T.Kato Co., Ltd.
4-1-1 Iidabashi, Chiyoda-ku, Tokyo
102-0072
Email:info@t-kato.co.jp

“T.balance” Notice of specification change

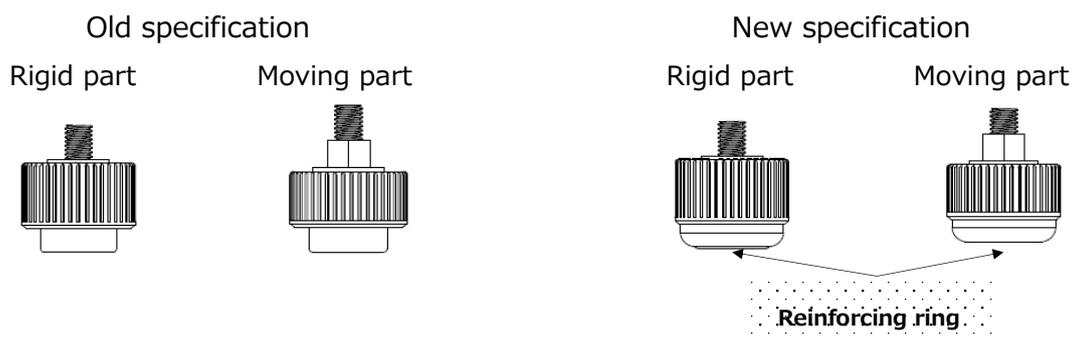
We attached a reinforcing ring to the bottom of the main body in order to move the table smoothly on a stepped floor such as terracotta.

※No change in width and height. W(33 mm)×H(27 mm)
